Sundry Print Report

Procedure Description: : Variance Request Matador requests a variance to have the option of running a multi-bowl wellhead assembly for setting the intermediate 1, 2 and Production Strings . The BOP s will not be tested again unless any flanges are separated. Matador requests a variance to drill this well using a co-flex line between the BOP and choke manifold. Certification for proposed co-flex hose is attached. The hose is not required by the manufacturer to be anchored. If the specific hose is not available, then one of equal or higher rating will be used. Matador requests a variance to have the option of batch drilling this well with other wells on the same pad. In the event that this well is batch drilled, the wellbore will be secured with a blind flange of like pressure. When the rig returns to this well and BOPs are installed, the operator will perform a full BOP test Matador requests a variance for the use of a diverter along with a 2000-psi annular to be installed after running 20" casing. Matador requests the option to cut off 20" SOW wellhead and run 13-3/8" SOW multi-bowl wellhead system once 1st intermediate string is run and cemented. Both wellhead

21-1/4" Diverter Stack

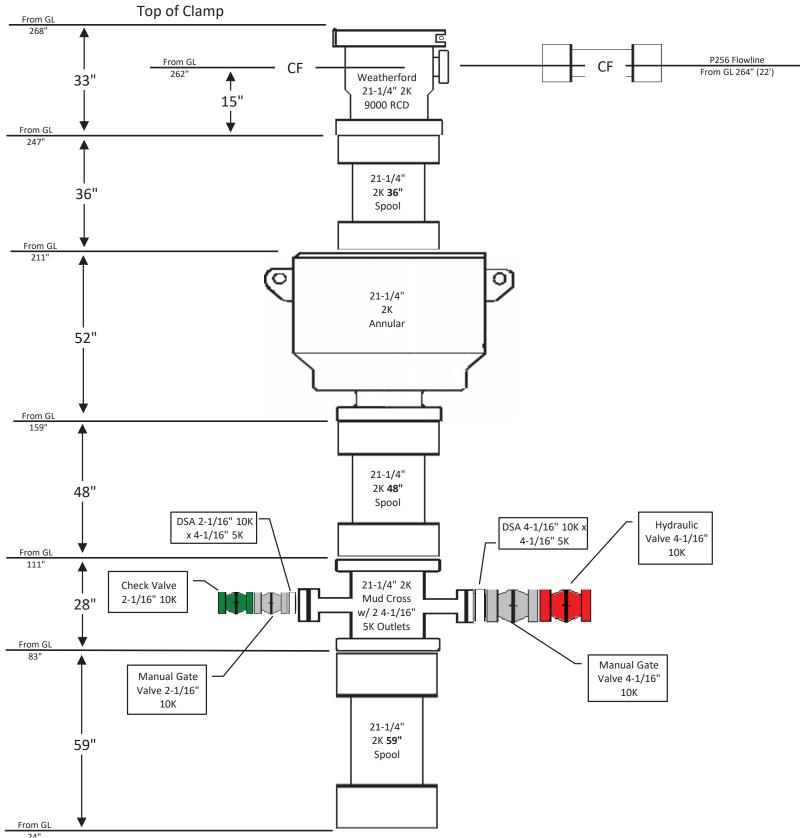
As per our conversation, we would like to seek approval to run a diverter system with a 2,000 (2M) psi annular to drill our shallow 1st intermediate string on my upcoming two wells.

The request was part of the original drill plan submitted for APD approval, as shown on the image below.

Minimum working pressure of the BOP/BOPE required for drilling below the surface casing shall be 2000 (2M) psi. A Diverter system along with a **2000 (2M) psi annular preventer** is approved to be used when drilling the 17-1/2 inch hole. Before drilling out the surface casing shoe, diverter system and annular preventer shall be tested in accordance with **title 43 CFR 3172** and **API Standard 53**.
